CITY OF OVERLAND PARK PLANNING AND DEVELOPMENT SERVICES

**SUBDIVISION NAME – ARBOR VIEW 8th PLAT
PIP2018-0002**

GRADING PLAN
 ARBOR VIEW, EIGHTH PLAT
 OVERLAND PARK, KANSAS

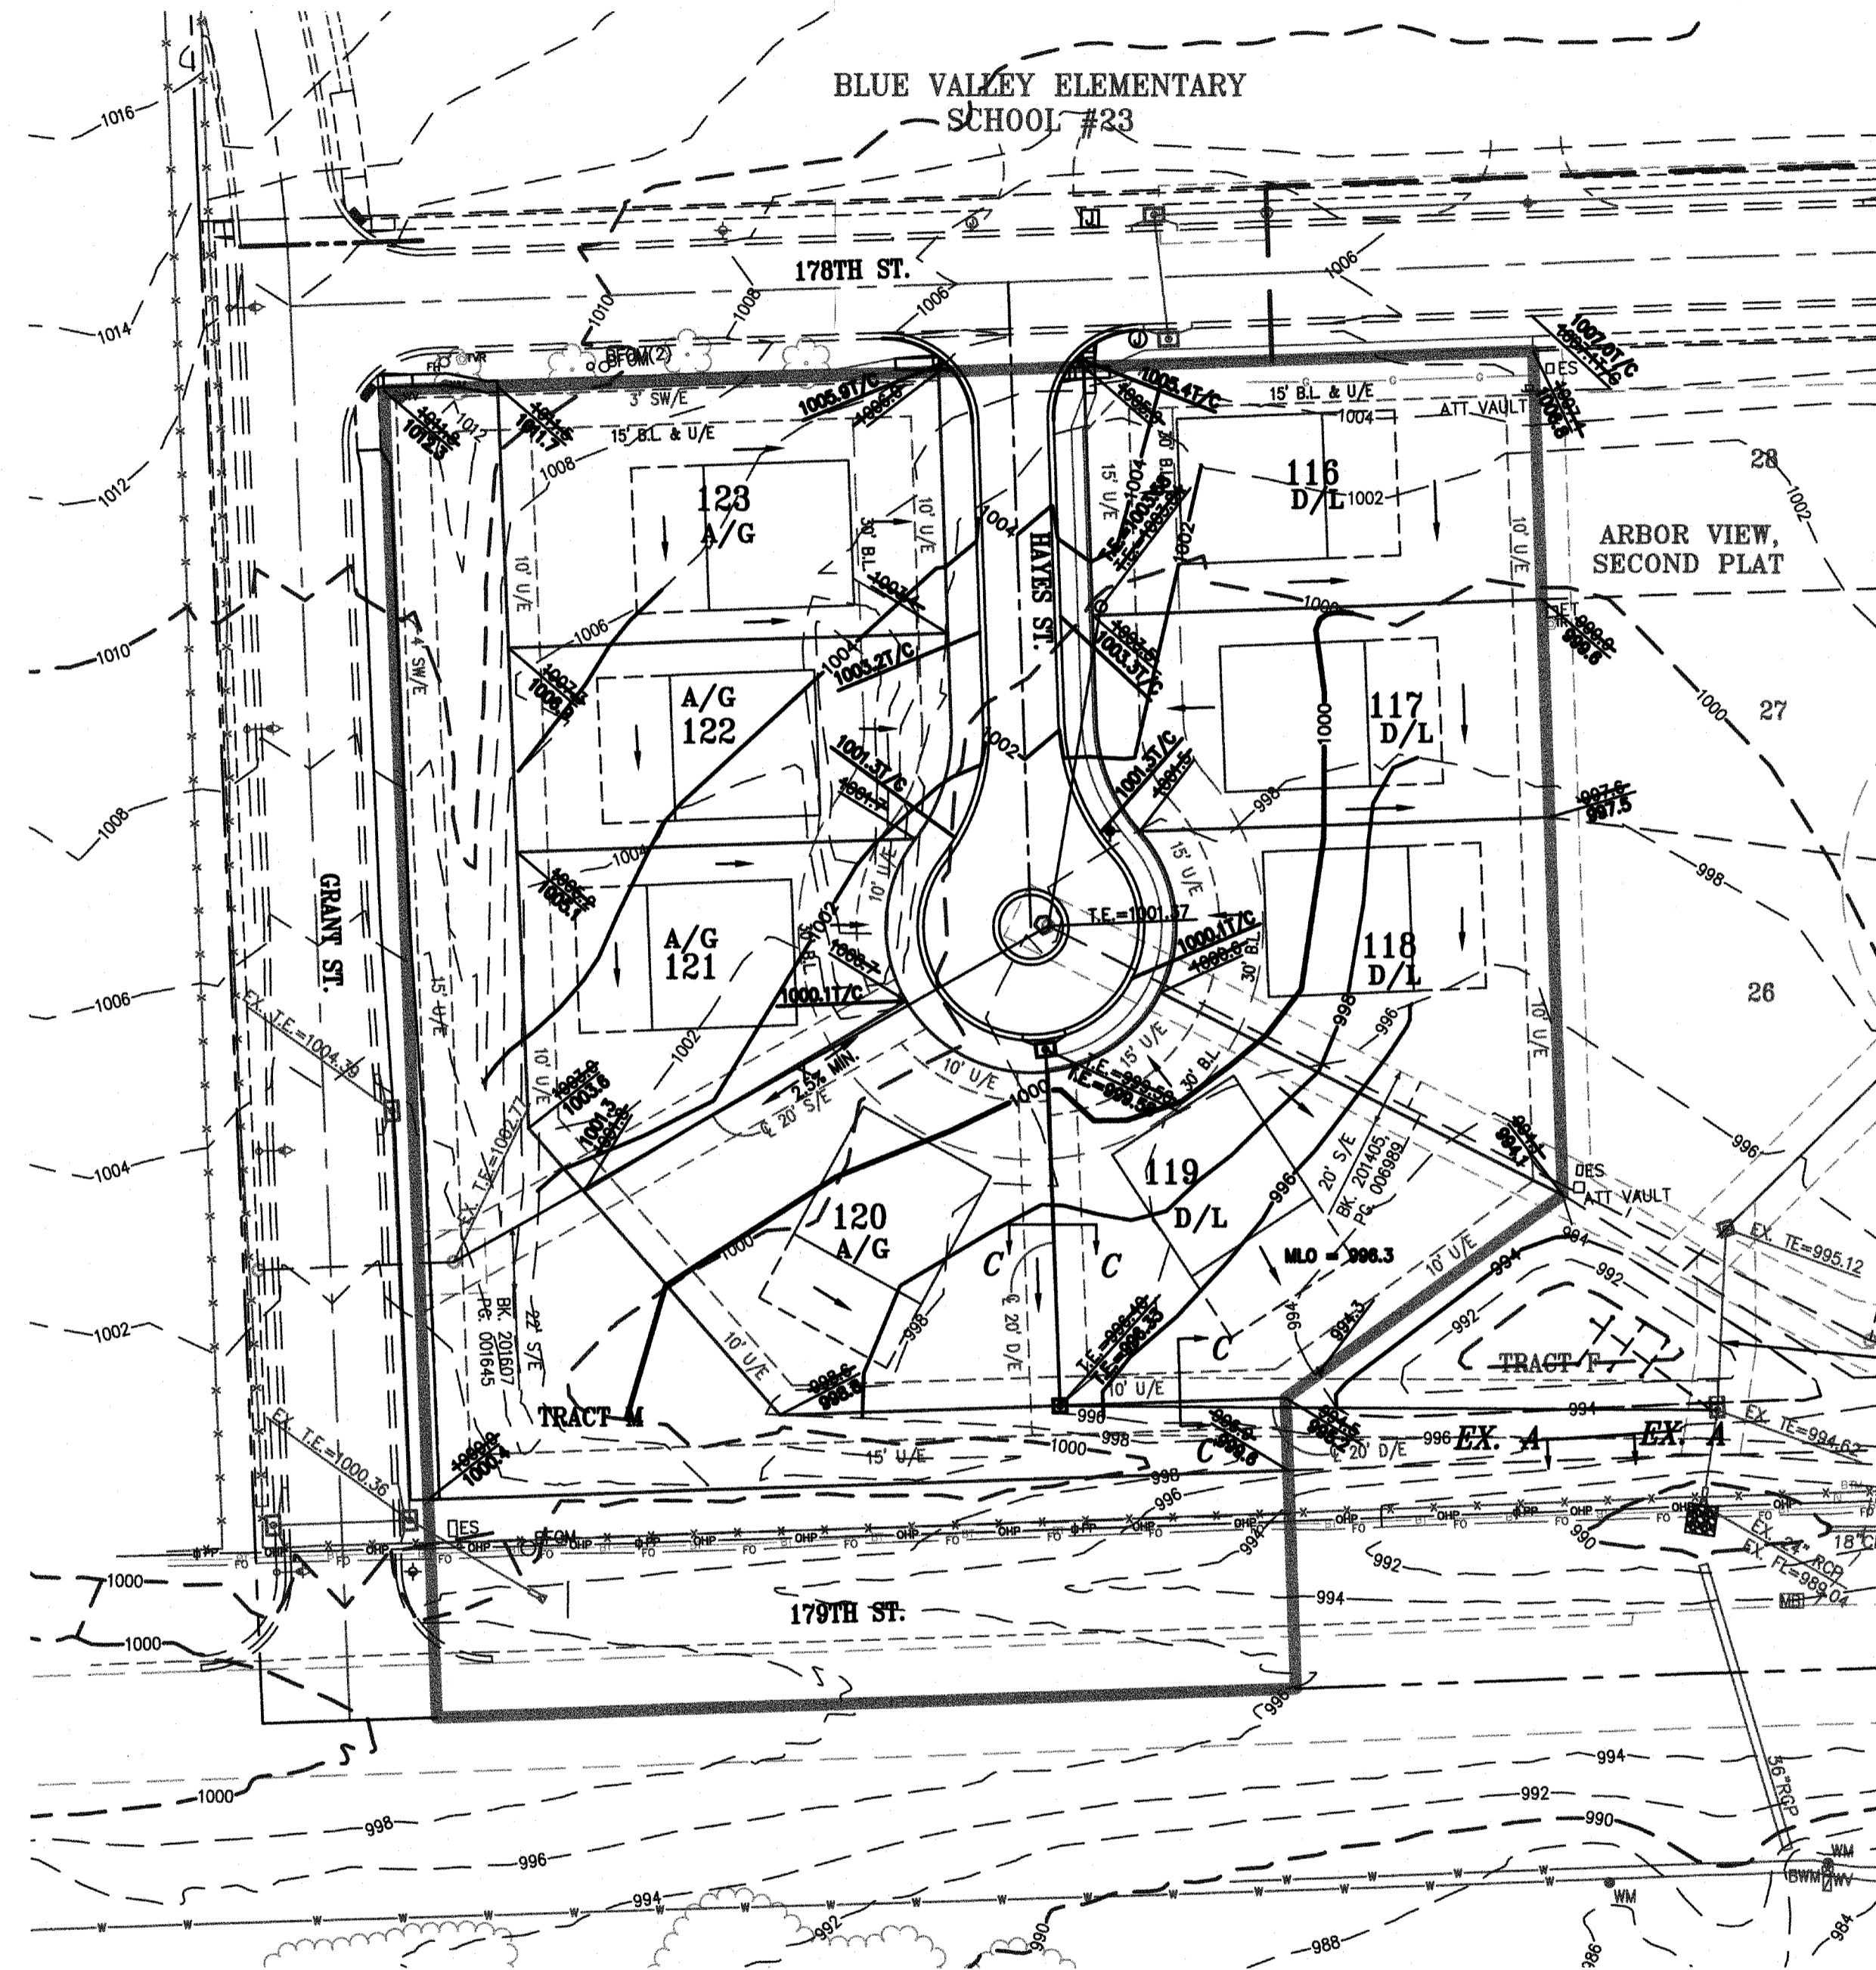
SWALE GRADING

The following lots include, or are adjacent to engineered swales designed for purposes of stormwater conveyance. An engineered plot plan is required for these lots in conformance with City requirements.

Minimum Low Openings must be a minimum of 1 foot above the 100-year storm energy grade line as measured perpendicular to the swale.

<u>LOT</u>	<u>SWALE</u>	<u>EGL DEPTH (FEET)</u>
119	C-C	0.36
120	C-C	0.36

MLO SET BY ENGINEER

The following lots are adjacent to large open stormwater conveyances which require freeboard for all building openings and tops of foundation walls. An engineered plot plan is required for these lots which show the minimum low opening established on the subdivision as-built grading plan and actual proposed building openings and top of foundation wall elevations.

LOT

MLO (All Building Openings)

119

996.3

LOT GRADING

The following lots require specific grading to ensure proper drainage paths between lots. An engineered plot plan is required for these lots which show the drainage paths based upon grading specified by the Engineer.

Lot

120

121
